LINCOLN ELECTRIC EUROPE

Service Notice N°: ESN0050 Rev. 0

Invertec 270sx & 400sx and Tomahawk 1025 & 1538 Fuse substitution

Valid for the following product for the equipment with serial number below I2100602462

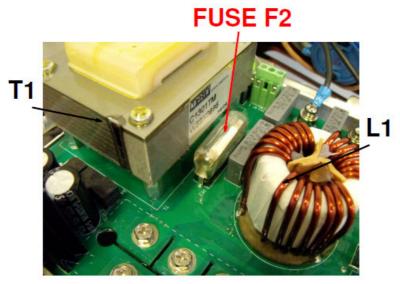
Input boards W05X0855-1 and 2 of these machine mount a 1.6A delayed fuse (F2). When the fan fails, shorting itself, the fuse doesn't blow up on due time. This problem carries the transformer T1 to fail.

For units with serial number below **I2100602462**, fuse must be substitute by a 0.5A delayed fuse (LEI code: W7300500R) so that the transformer is protected when fan shorts circuit happen.

Component Identification

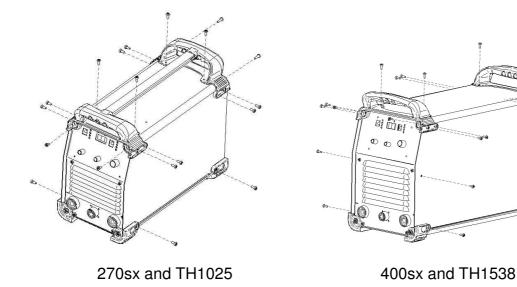
The fuse F2 is suited between the transformer T1 and the EMC inductance L1 on input board.

• Remove the red wraparound:

Remove the plastic cover of the fuse.

- Change the fuse with the new one. Verify the correct pressure of the contact forks.
- Replace the plastic cover.
 Put the wraparound and tighten all screws.
